**SHEARON HARRIS NUCLEAR POWER PLANT  
DOCKET NO. 50-400/LICENSE NO. NPF-63  
CHANGE TO EMERGENCY PLAN IMPLEMENTING PROCEDURES**

**CHANGES TO EMERGENCY PLAN IMPLEMENTING PROCEDURES**

<u>PROCEDURE NUMBER</u>	<u>TITLE</u>	<u>EFFECTIVE DATE</u>
PEP-340 Revision 10	Dose Assessment	07/25/03
PEP-350 Revision 6	Protective Actions	07/29/03

**PROCEDURE TYPE:** Plant Emergency Procedure  
**NUMBER:** PEP-340  
**TITLE:** Dose Assessment

### 3.3 Basic Program Flow Diagram

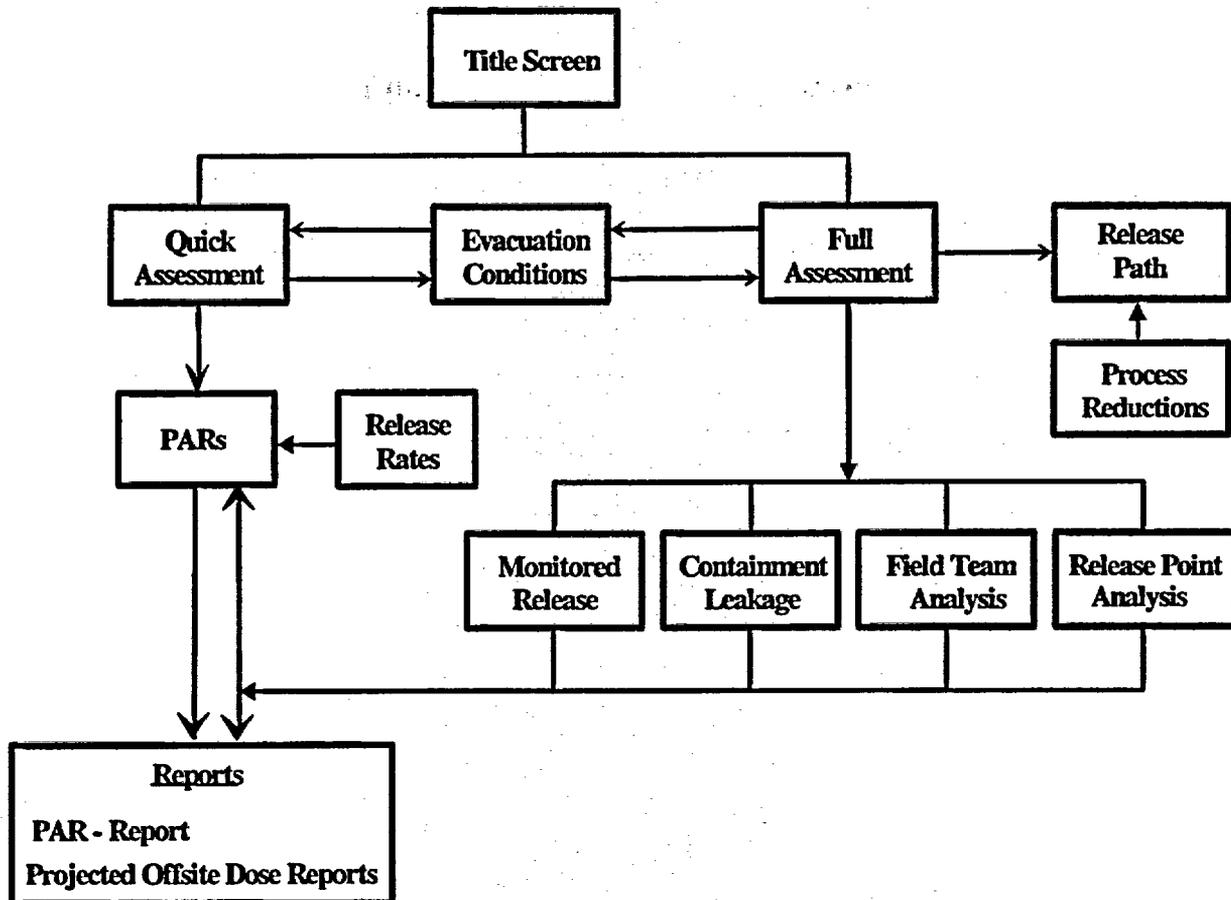
3.3	Corrected flow arrows on flowchart.
3.5.4.d	Added this step for determining stability class with only one ERFIS $\Delta T$ channel available.
3.5.4.e	Updated the stability class determination table to reflect corrected surface wind speed.
